Application for a Non-Material Amendment Following a Grant of Planning Permission

Proposed extension to ground, first and second floors to create new lift and lobby with disposal hold. Internal alterations to second floor to provide a new ward and ancillary accommodation. New external plant compound at ground floor adjacent to the building with roof mounted plant at roof level.

20/00595/FUL

Slight enlargement of proposed lift shaft. External ground floor facing material change.

sultability: - purpose: Planning drg no: 4072-EXI-304-P4					
suitability	/· _	purpose:	Planning		
checked: LV		scale (A1):	1:100		
drawn:	НС	date:	25.02.2022		
title:	Proposed Blo	ck Plan			
job:	SSD - Glouce	SSD - Gloucestershire Royal Hospital			
client:	Gloucestershire Hospital NHS FT

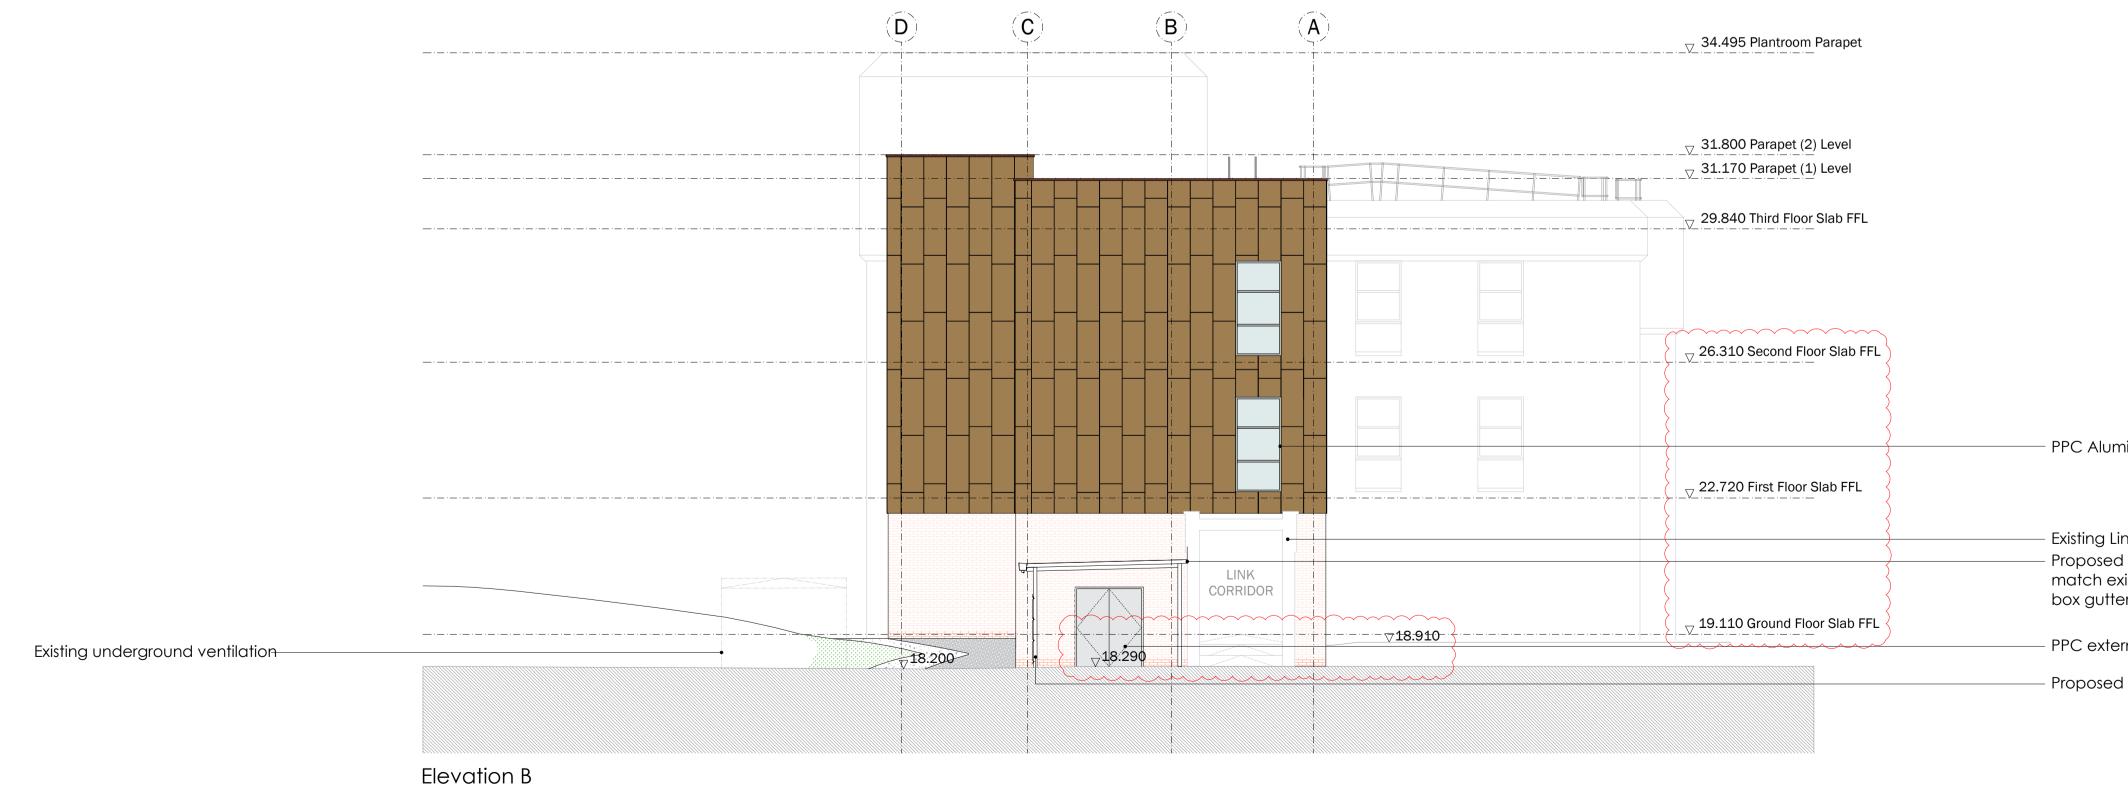
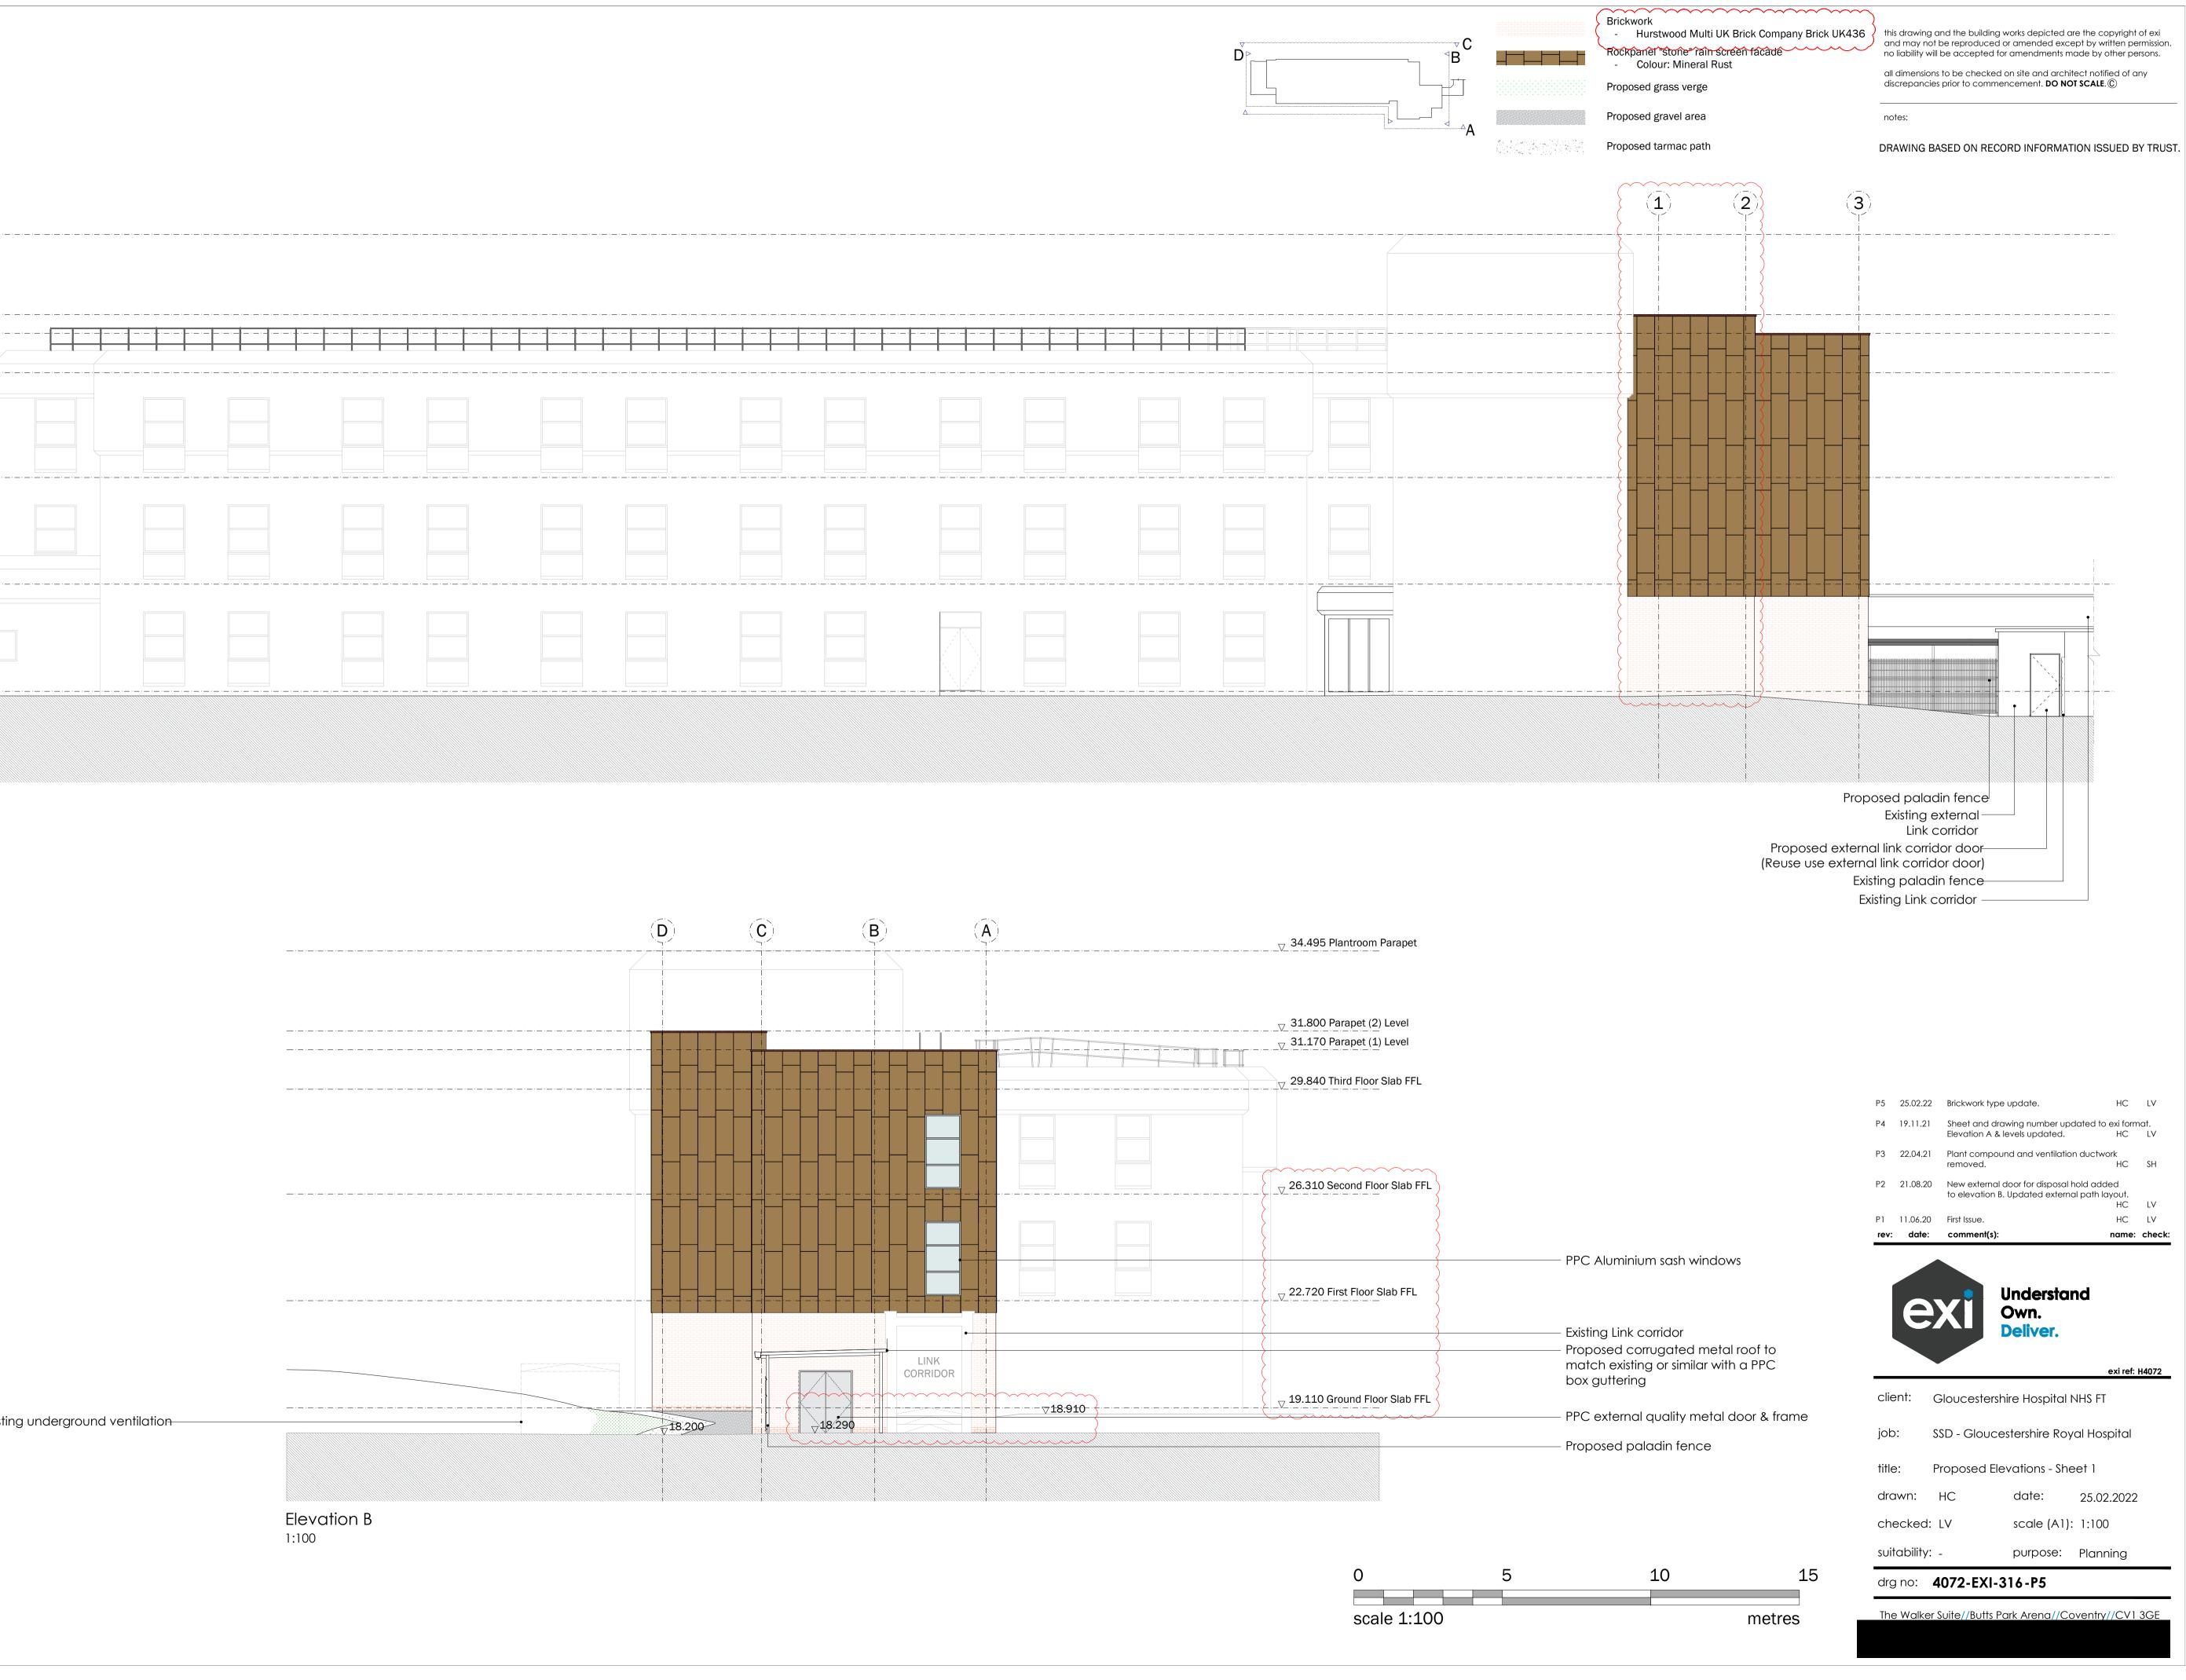
rev:	date:	comment(s):	name:	check:
Р1	11.06.20	First Issue.	HC	LV
P2	21.08.20	External path way updated.	HC	LV
P3	22.04.21	Plant compound removed and path re-aligned to suit.	SH	SH
P4	25.02.22	Drawing number & sheet updated to ex Proposed extension foot print adjusted or re-aligned to suit.

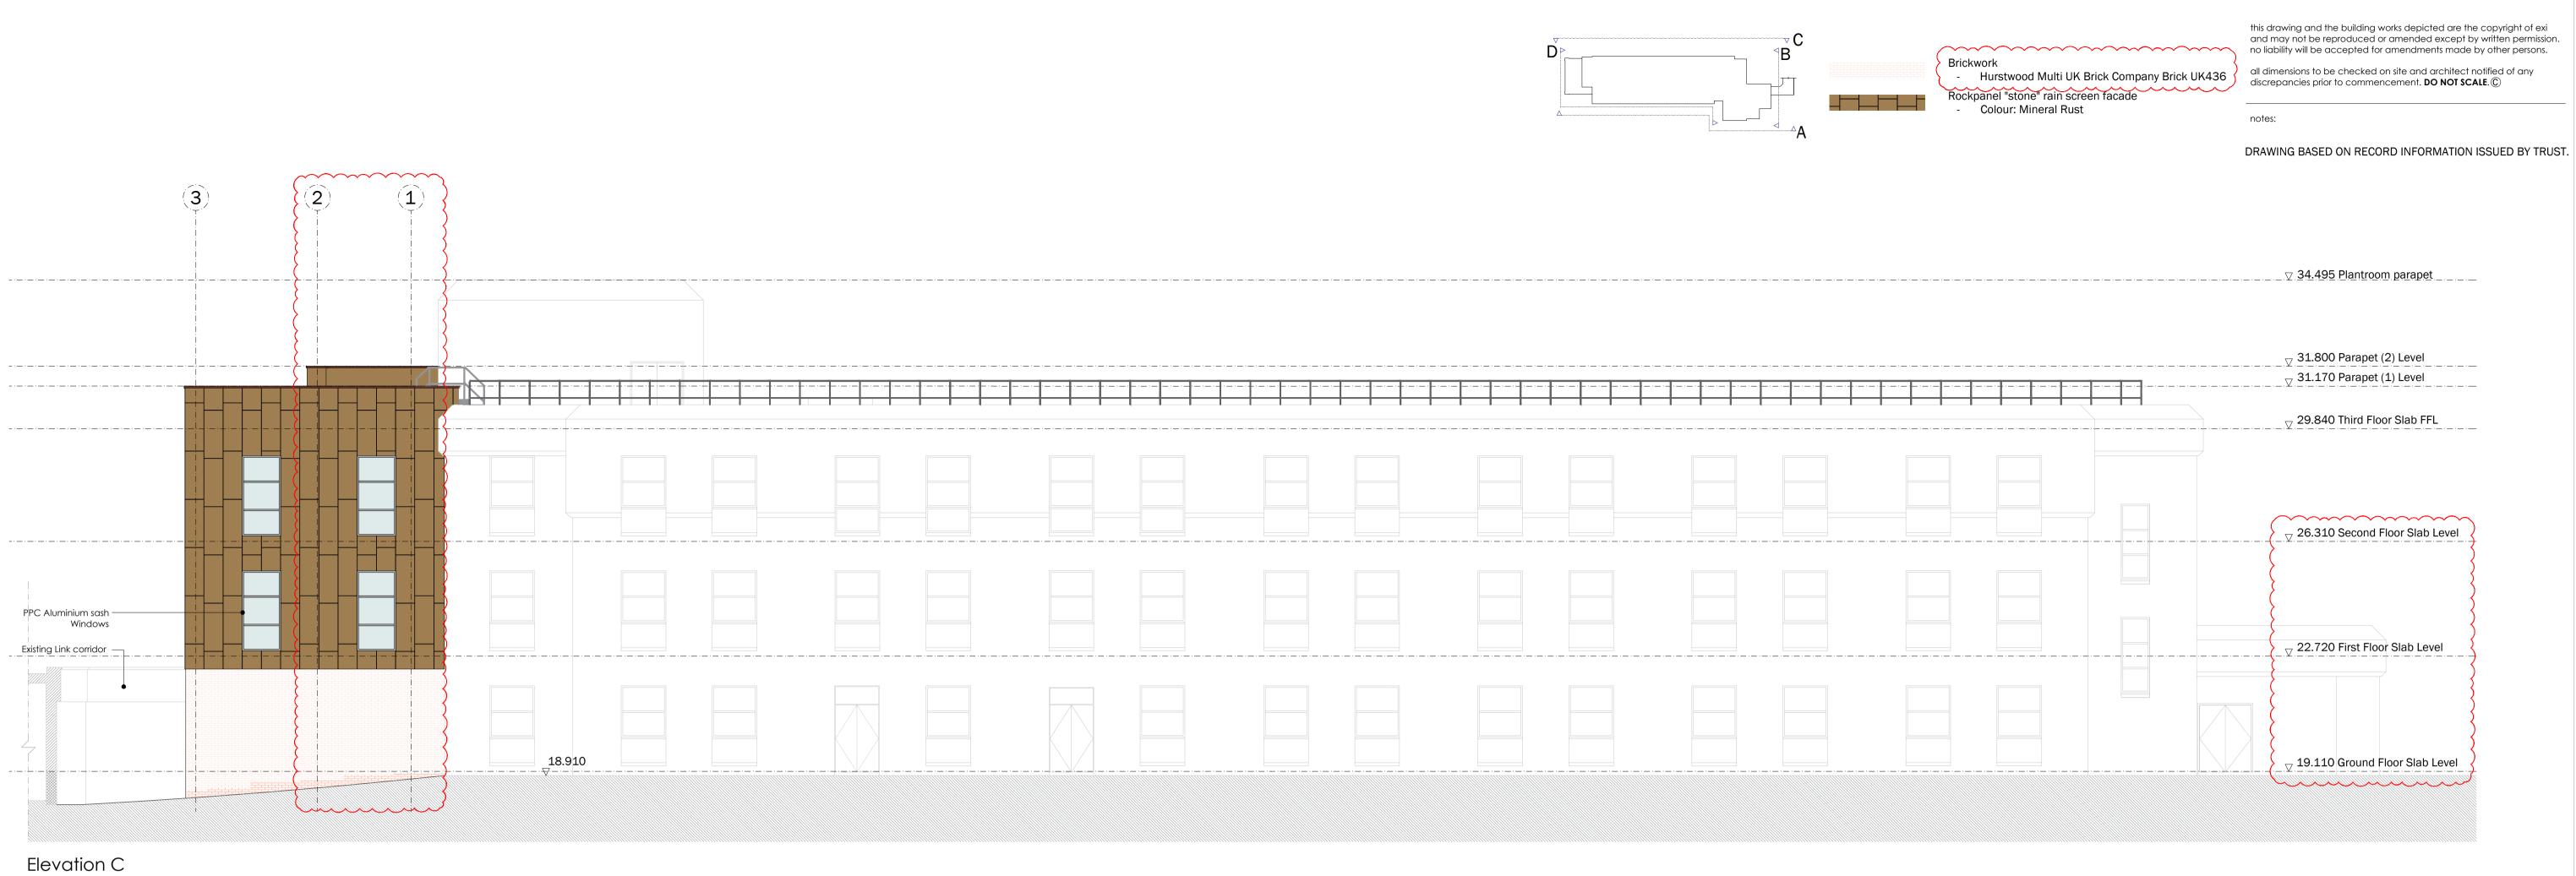
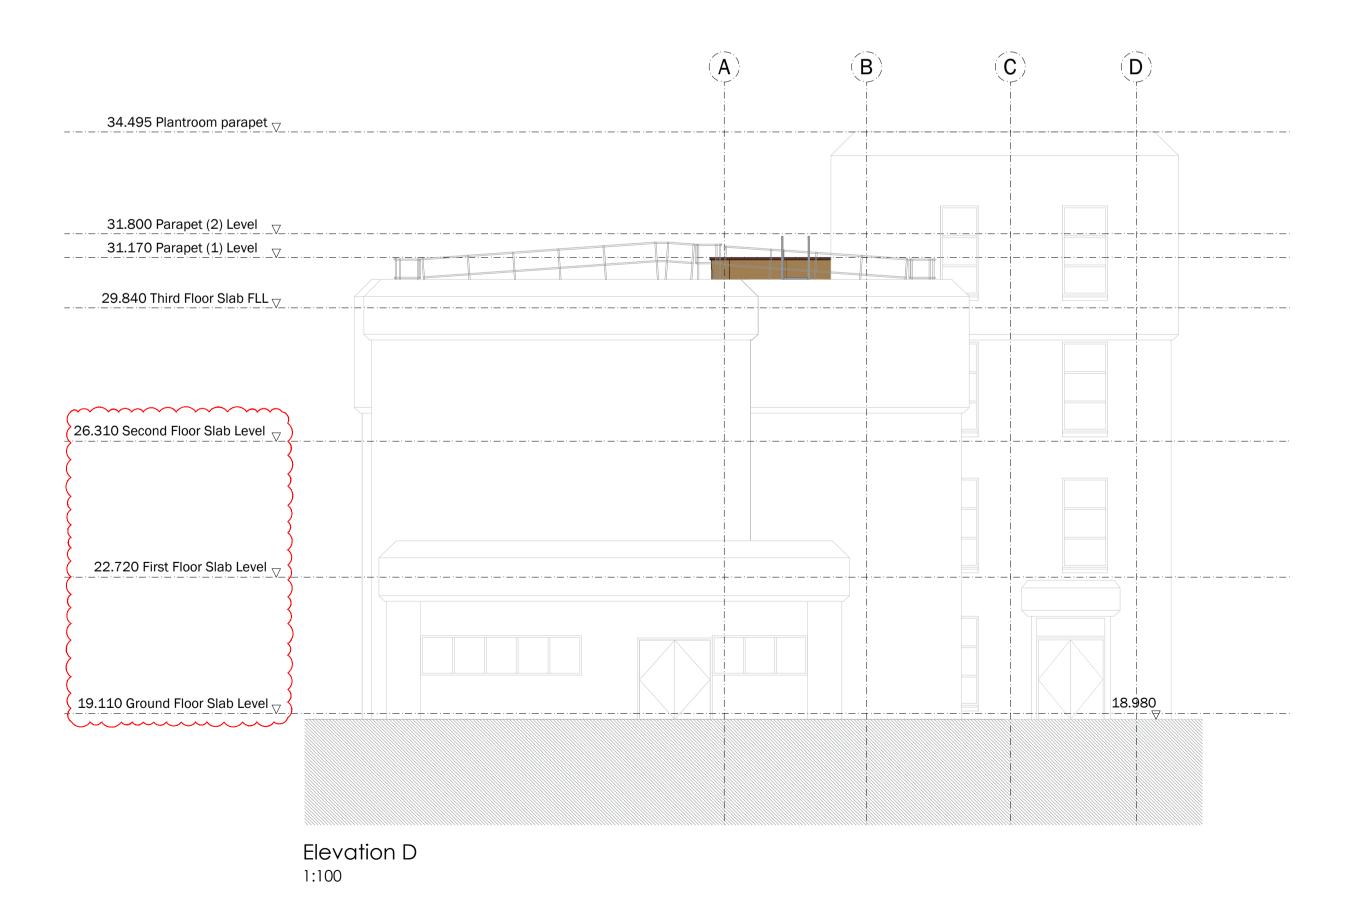
rev:	date:	comment(s):	name:	check:
P1	11.06.20	First Issue.	HC	LV
P2	21.08.20	Updated external path layout.	HC	LV
Р3	22.04.21	Plant compound and ventilation ductw removed.	ork HC	SH
P4	19.11.21	Sheet and drawing number updated to Elevation C & levels updated.	exi form HC	nat. LV
P5	25.02.22	Brickwork type update.	HC	LV

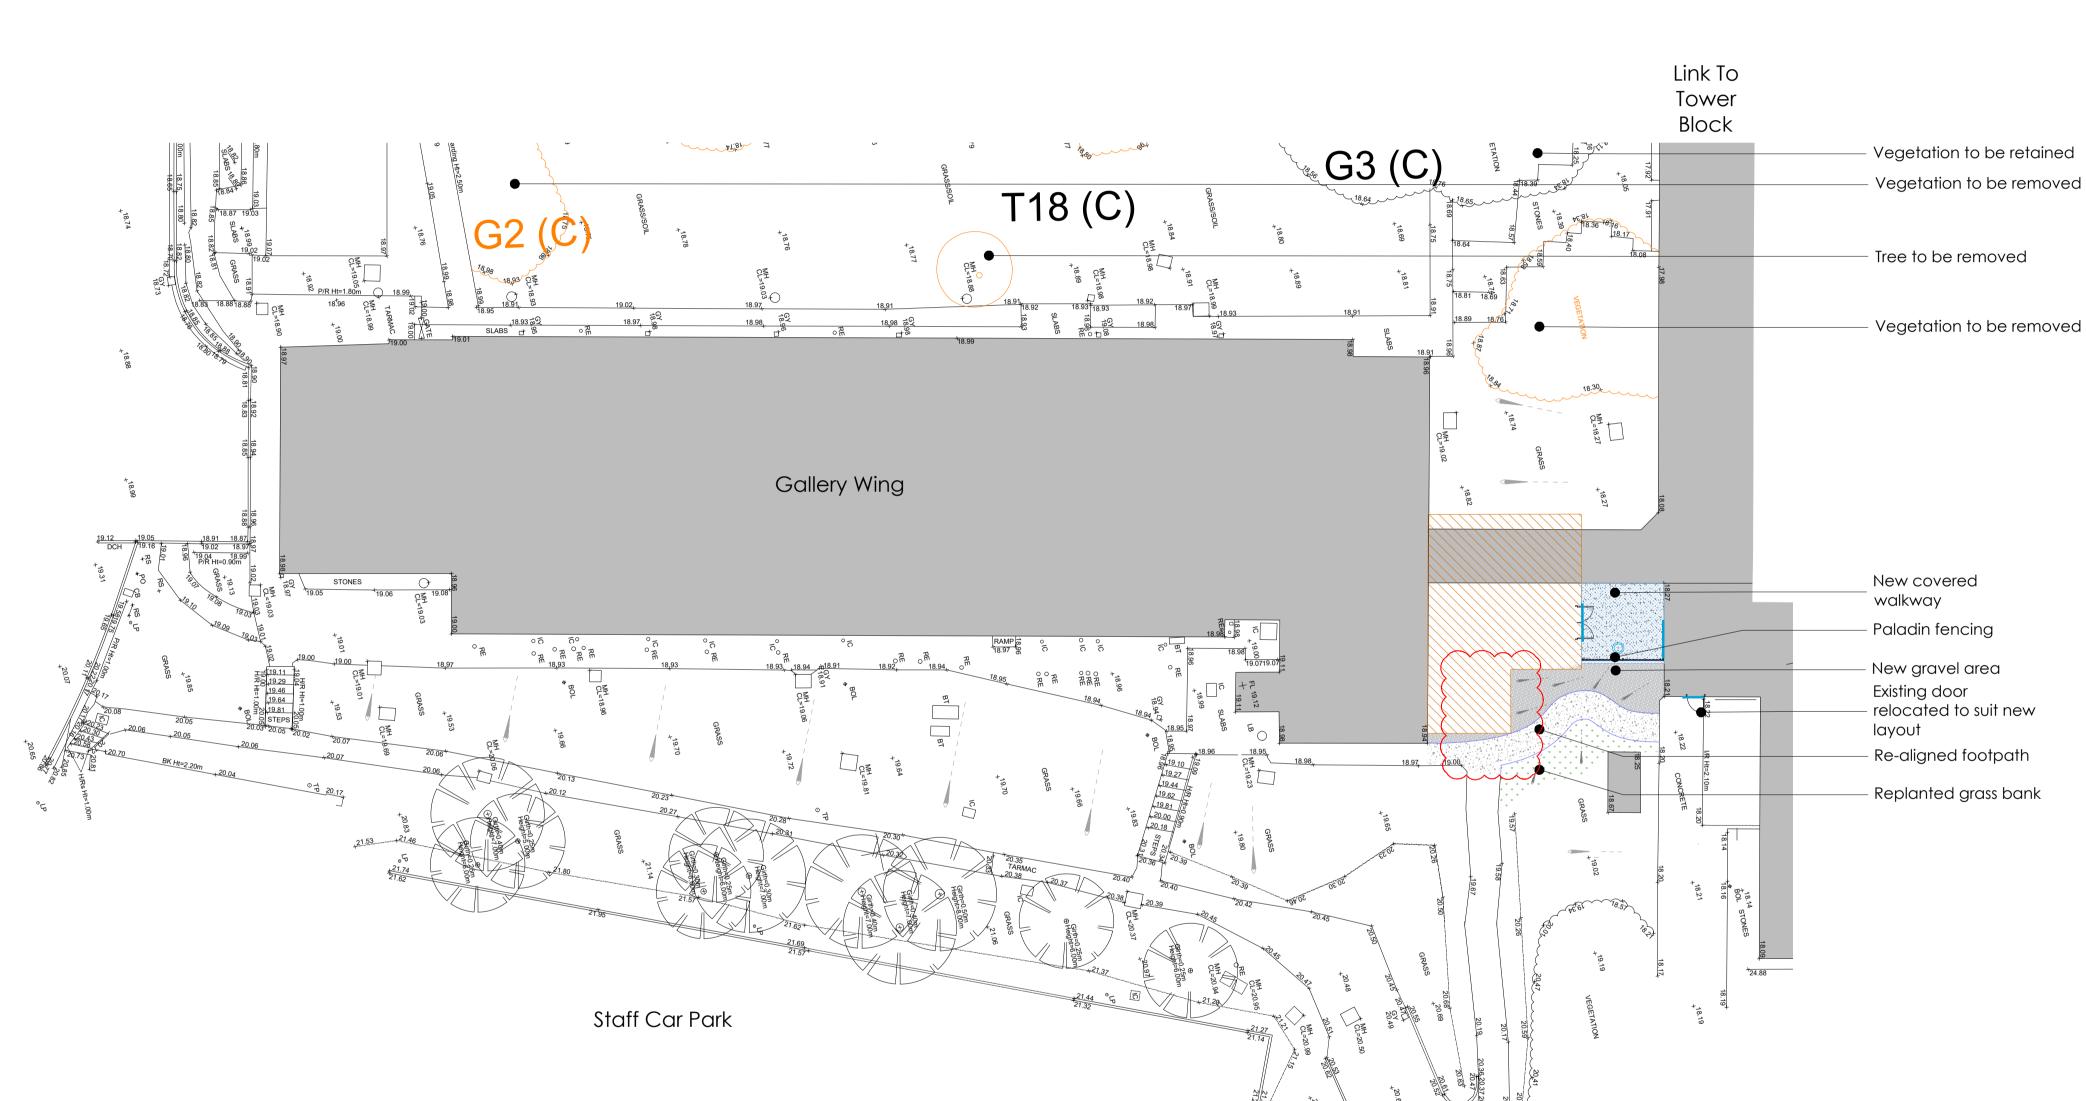
rev:	date:	comment(s):	name:	check
P1	11.06.20	First Issue.	HC	LV
P2	21.08.20	External path way updated.	HC	LV
P3	20.04.21	Plant compound removed and path re-aligned to suit. Soft landscaping specification added	AG	SH
P4	25.02.22	Drawing number & sheet updated to ex Proposed extension foot print adjusted c re-aligned to suit.
